Product Update Memo

May, 2006

Bourns® Sensors & Controls Division Announces Model 3540 Series Material Change

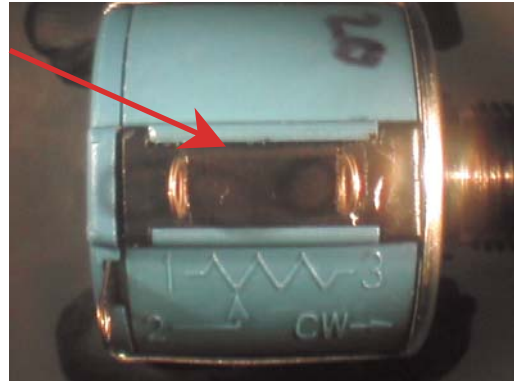
Bourns® Sensors and Controls Division will be changing the plastic material used in molding the terminal block of our Models 3540, 3541, 3543 and 3545. The change from Fortron 6165A4 to Thermocomp® OF-1008 is due to a phase out of the Fortron material at our current supplier and the lack of availability from other suppliers.

Thermocomp® material is equivalent to the Fortron material and has been qualified for use in the standard 3540 series product. Please reference the adjacent photo identifying the terminal block. There is no change in fit, form or function on any of the models listed.
